CABINET MEMBER FOR ENVIRONMENT – 10 OCTOBER 2013**PROPOSED REMOVAL OF PARKING BAY
LIME WALK, HEADINGTON, OXFORD****Report by Deputy Director for Environment & Economy (Commercial)****Introduction**

**new parking restrictions in Lime Walk
Headington Central**

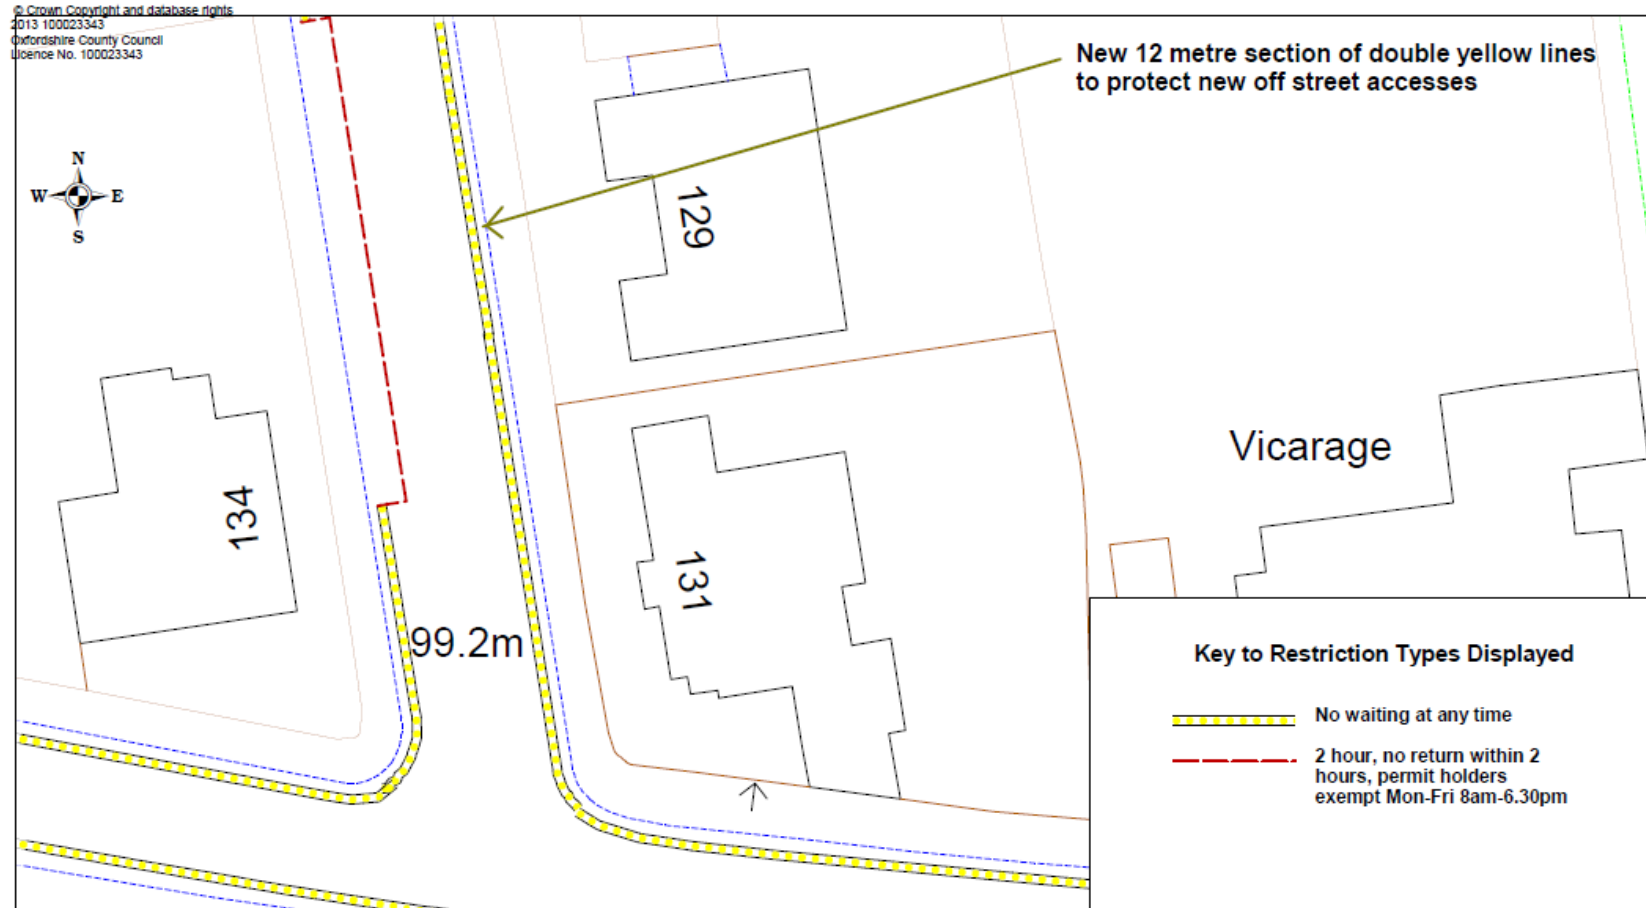
bay. Copies of these objections are available for inspection in the Members' Room but can be summarised as (a) that the proposal does not accord with the planning consent for the site and (b) the presence of the parking bay (when occupied) is a key element of the current and emerging traffic calming scheme in Lime Walk and, therefore, its removal will increase traffic speed and also have a negative impact on pedestrian safety at the Old Road junction.

6. Following receipt of these objections Oxford City Council have confirmed that the development and associated off-street parking places (and thus the dropped kerb) have been built in accordance with the permissions for the site and that the developer has complied with all the permissions for the site. It has become clear that since the substantive consent was issued in June 2012, the developer applied in April 2013 to vary a number of aspects of the development, which included the layout of the off-street parking. This application was consulted on by the City Council and received no objections.

7. The development of a comprehensive traffic calming scheme for Lime Walk has been the subject of discussions with the local community for some time. The junctions at Old Road and All Saints Road were treated in 2012 but there are currently no plans agreed for further features. It is acknowledged that removal of the single space outside 129 Lime Walk will reduce any traffic calming benefits that it may have given when a vehicle was actually present, given the general layout of parking bays elsewhere in this part of the street. However, the effect is likely to be minor. Further, should a traffic calming scheme be developed in the future alternative methods to narrow the road (such as a small build-out or planter) could be placed in the vicinity of No 129.

18. **The Cabinet Member for the Environment is RECOMMENDED to approve the advertised parking restriction for Lime Walk, Headington as set out in this report.**
